ROCHE GROUP PTY LIMITED

TRANSPORT ASPECTS OF
REVISED PLANNING PROPOSAL
FOR PROPOSED MIXED USE
DEVELOPMENT, 469-483
BALMAIN ROAD, LILYFIELD

JUNE 2017

Existing weekday morning peak hour traffic flows plus development traffic

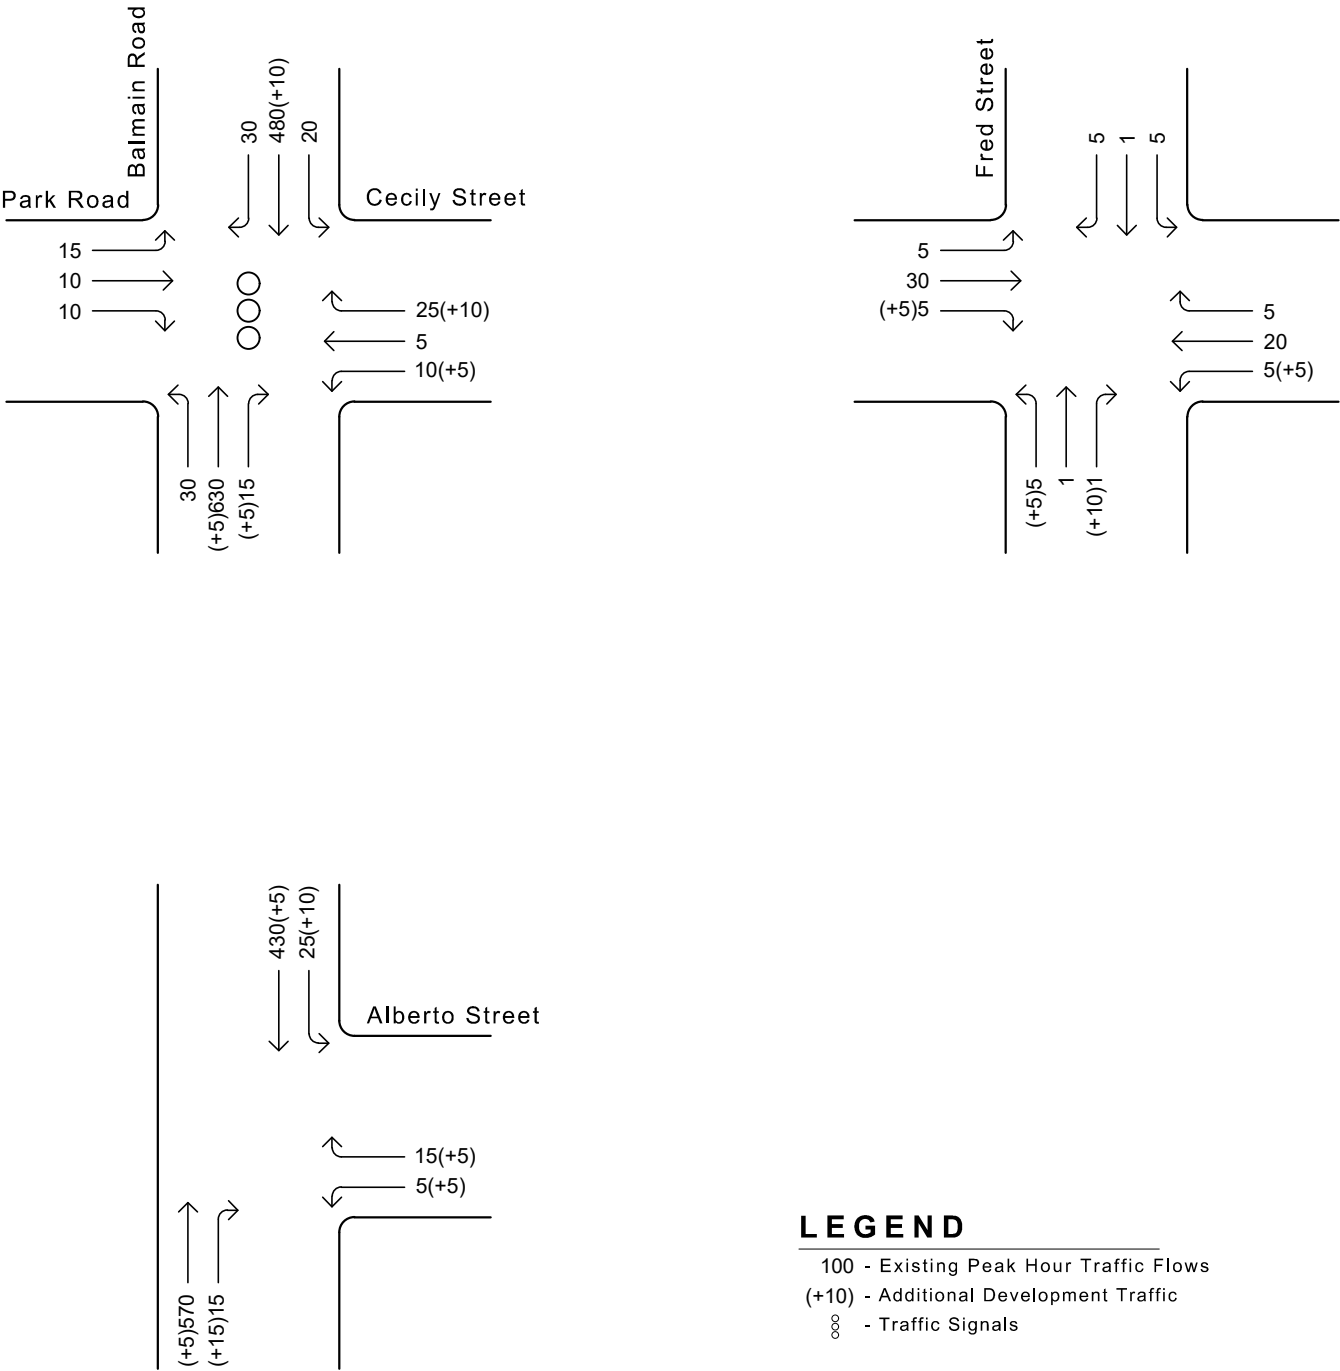
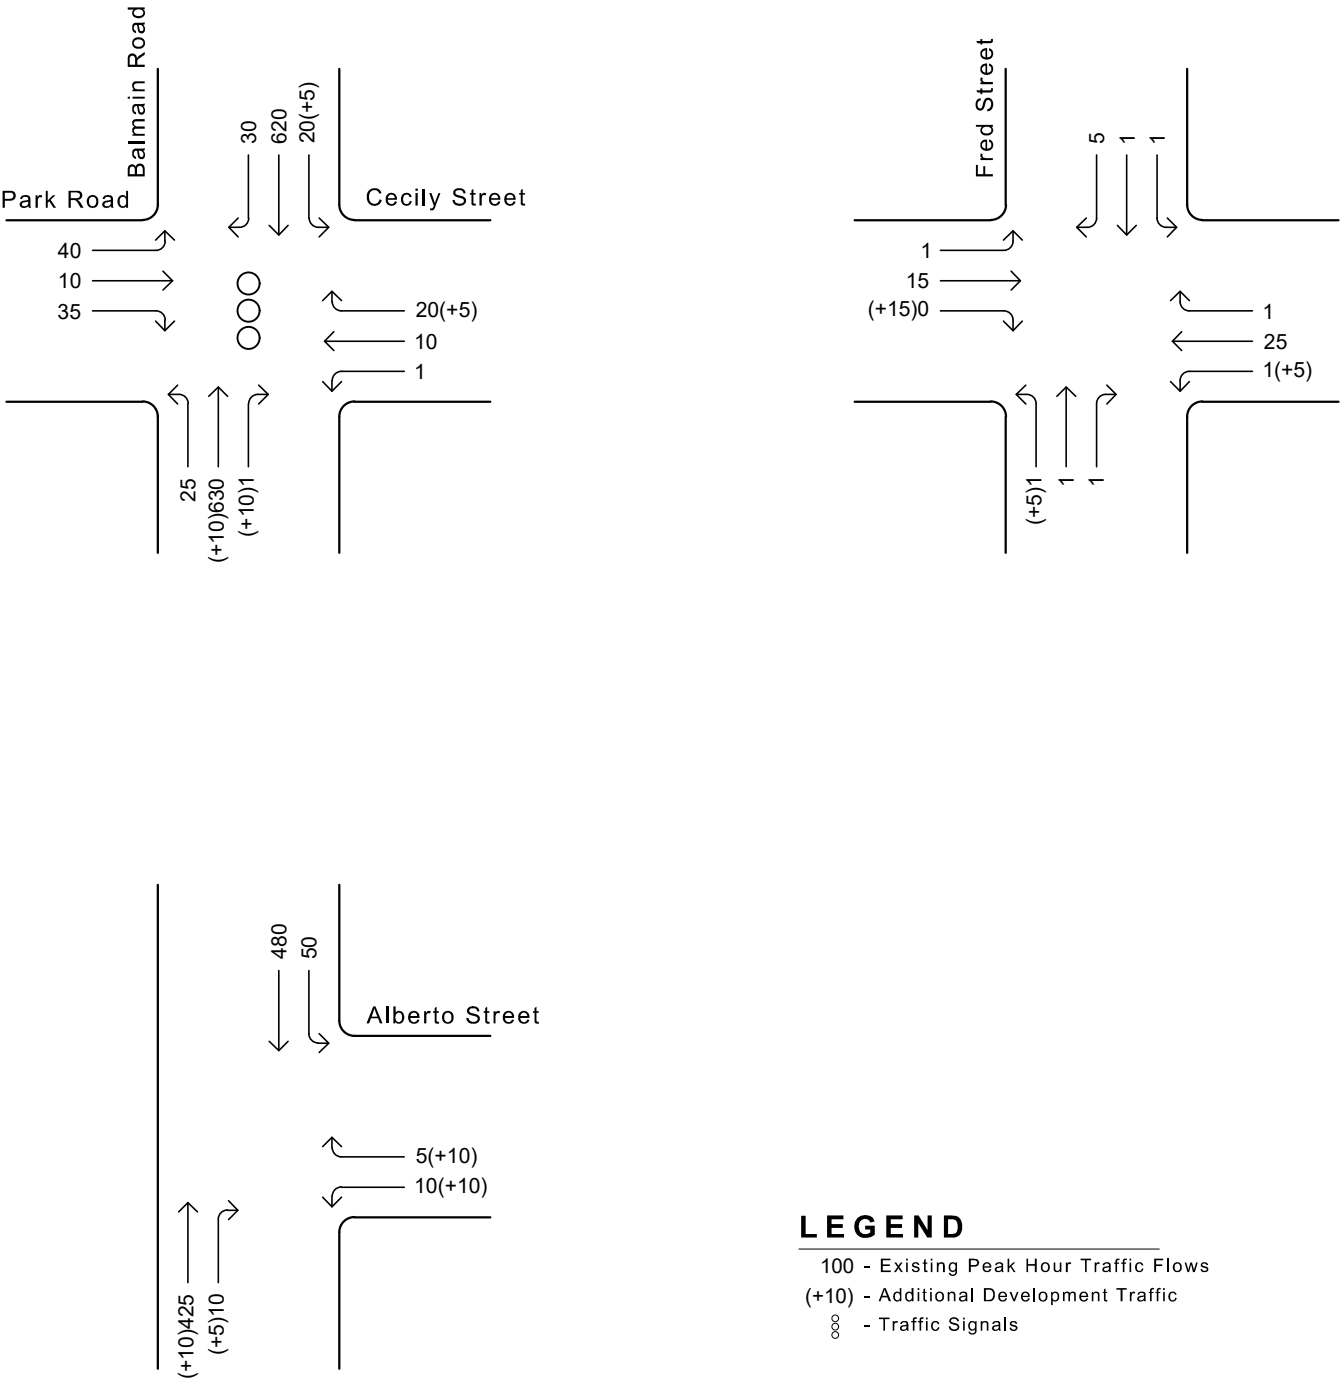
- *predicted origin/destination information, projected onto the intersection of Alberto Street and Balmain Road, particularly in relation to potential right turn movements out*

of Alberto Street. This information should be considered in relation to elements such as sightline limitations at the intersection; conflict with Balmain Road bike routes and pedestrian activity

- 2.30 The matters raised by council are addressed below.
- *predicted origin/destination information, projected onto the intersection of Alberto Street and Balmain Road, particularly in relation to potential right turn movements out of Alberto Street. This information should be considered in relation to elements such as sightline limitations at the intersection; conflict with Balmain Road bike routes and pedestrian activity*
- 2.31 The distribution of traffic to and from the proposed development for morning and afternoon peak hours is shown in Figures 2 and 3. Most traffic would travel to and
-
-

from Balmain Road. A smaller proportion would travel to and from the south along Alberto Street and Cecily Street.

2.32 As shown in Figures 2 and 3, the number of vehicles turning right into Balmain Road from Alberto Street would remain low. The SIDRA analysis indicates that the intersection will readily cater for these low movements.

Existing Saturday midday peak hour traffic flows plus development traffic

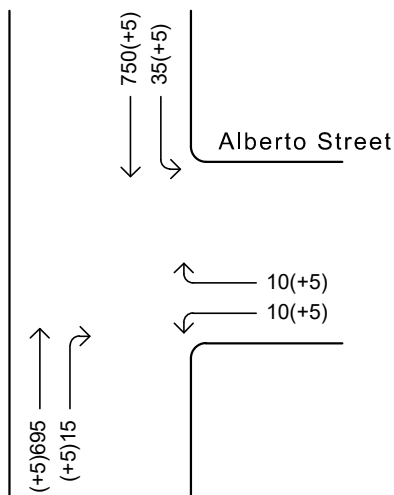
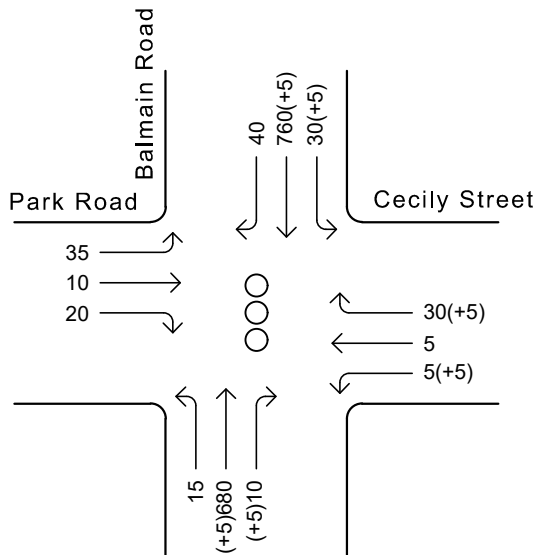
A Traffic and Parking Assessment should include traffic and parking analysis for weekends (Saturday mid-day) that outlines how the development could minimise impact on local traffic and potential conflicts with other activities on nearby sites such as the Callan Park primary entry that is located directly opposite the subject site. The assessment should take into account the site's proximity to:

- Callan Park and weekend events that occur on site*
 - weekend markets at Orange Grove and Rozelle Public School*
 - sporting events at Leichhardt Oval*
-

- 2.48 We have undertaken traffic counts at the Balmain Road intersections (Cecily Street/Park Road and Alberto Street) on a Saturday. The result of the surveys are shown in Figure 4, and summarised in Table 2.2.

- 2.49 Traffic flows on Balmain Road were some 1,500 to 1,600 vehicles per hour two-way during the surveyed peak hour. Flows on Park Road were some 130 vehicles per hour two-way. Alberto Street and Cecily Street carried less than 100 vehicles per hour two-way.
-

2.52 The Balmain Road intersections have been analysed using SIDRA for the additional development traffic flows shown in Figure 4. The analysis found that the intersection of Balmain Road with Cecily Street would operate with average delays of less than 15 seconds per vehicle during Saturday peak periods. This represents level of service A/B, a good level of service.
